WIRING OF THE NEUTRAL
SAFETY SWITCH ON "93"
MODEL YEAR CHASSIS

WIRING OF THE NEUTRAL SAFETY SWITCH ON "94" MODEL YEAR CHASSIS

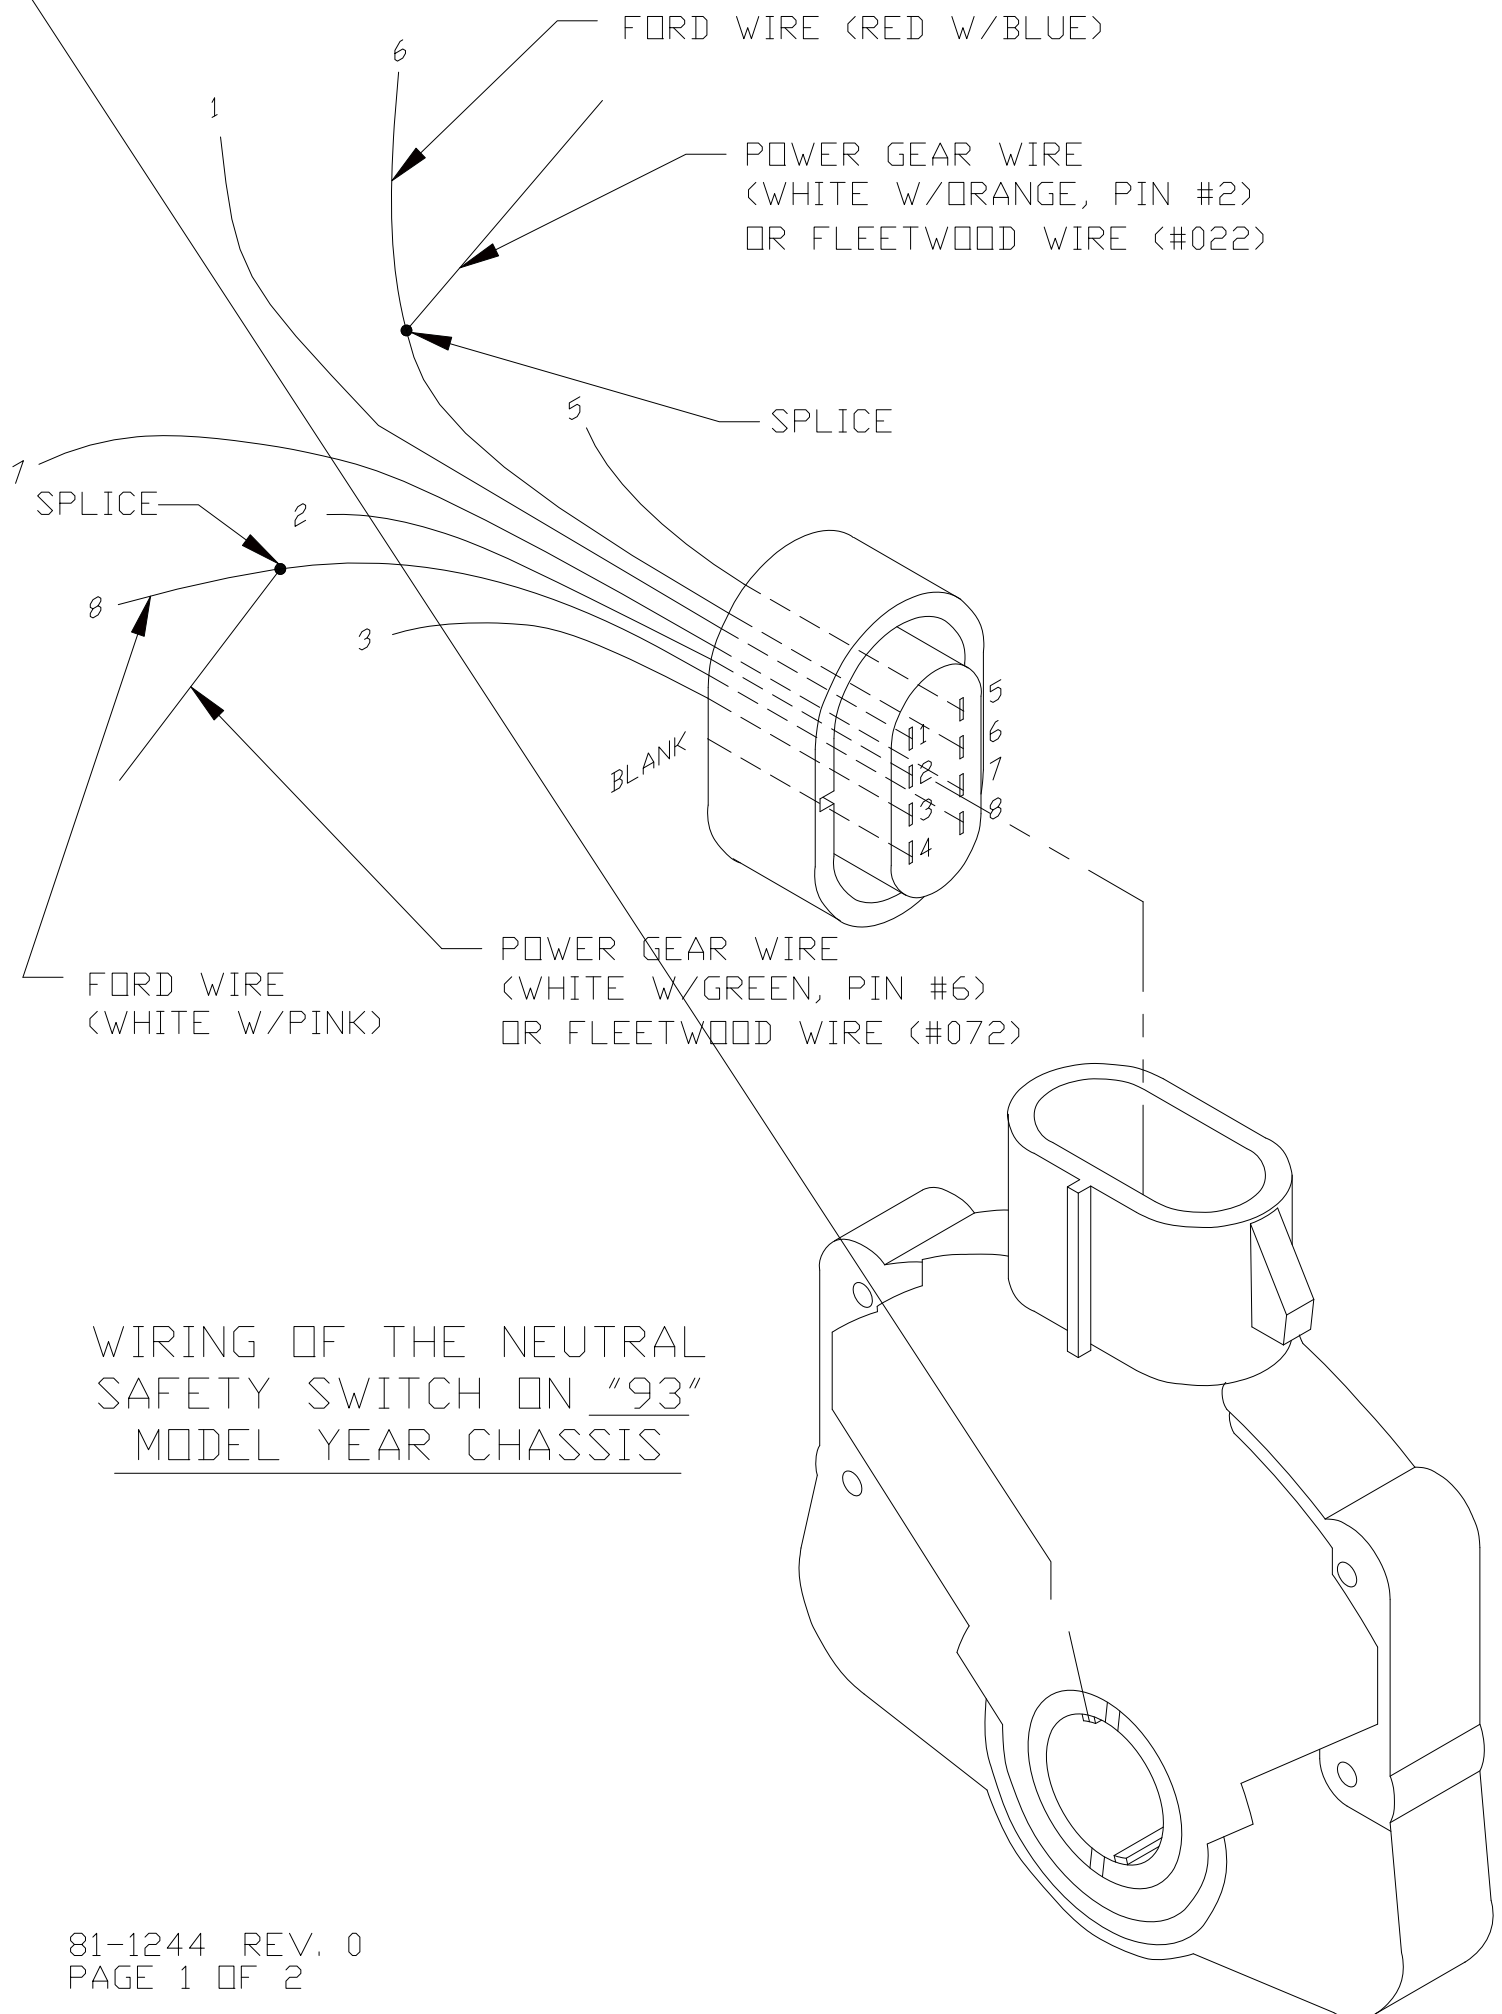
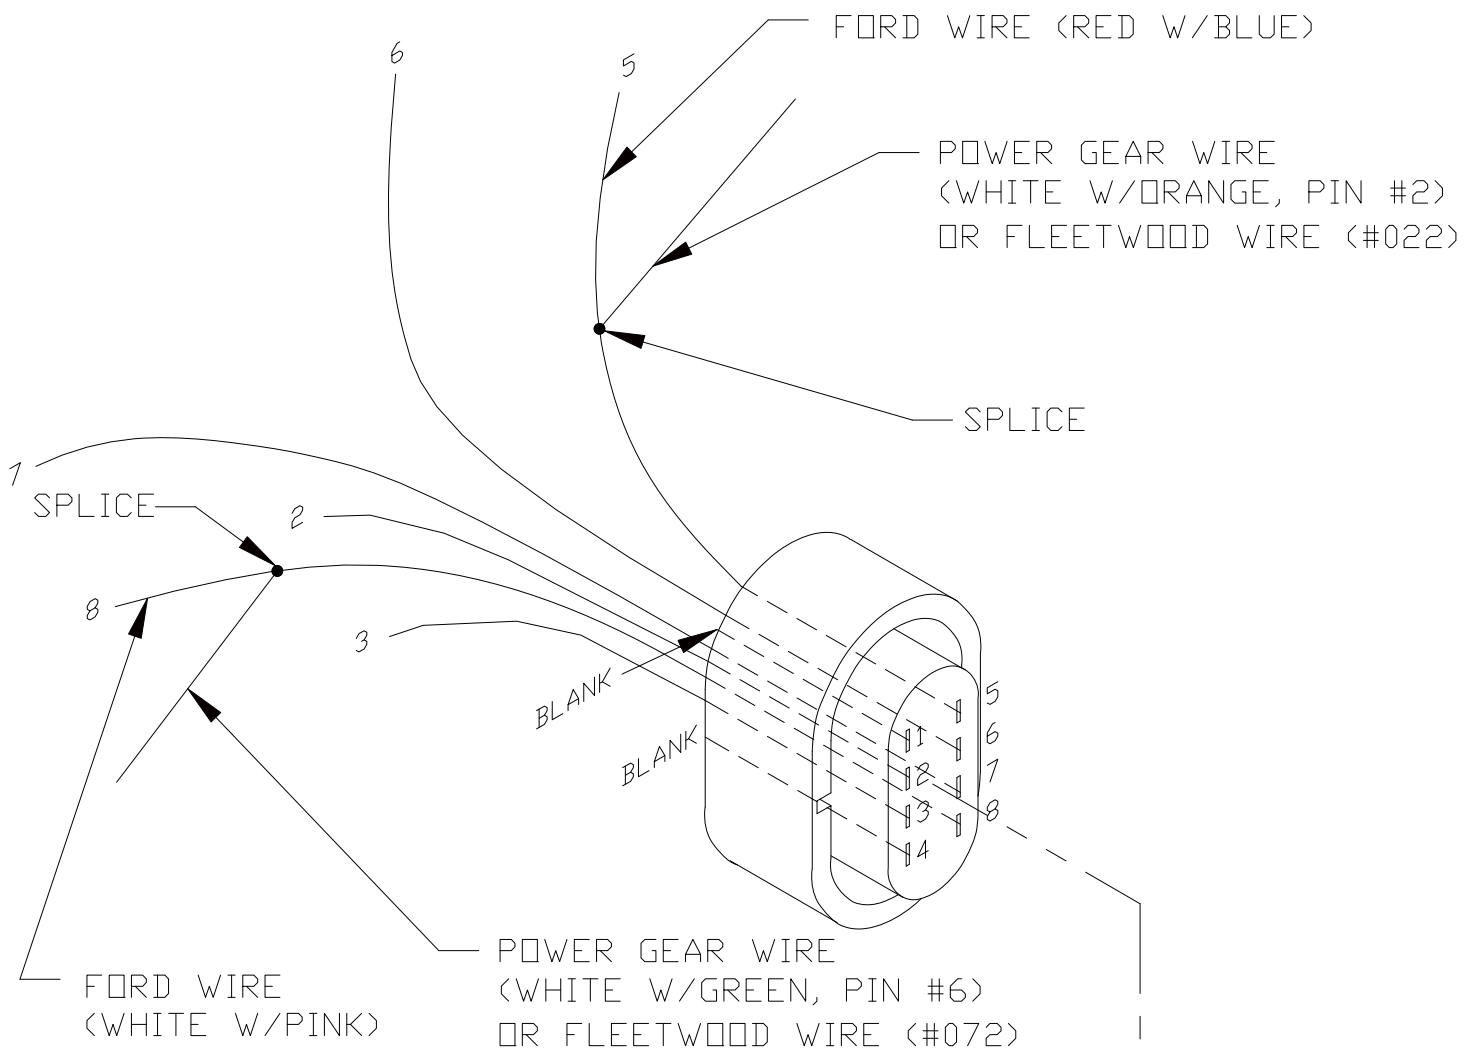
FORD CHANGED IT'S WIRING OF THE 8 PIN PLUG IN '94. THE RED W/BUE WIRE MOVED FROM PIN 6 TO PIN 5. THE MIL. CYL. WIRE OR FLEETWOOD WIRE (WHICH EVER IS USED) WILL REMAIN SPLICED TO THE RED W/BUE WHERE EVER IT'S LOCATION MAY BE.
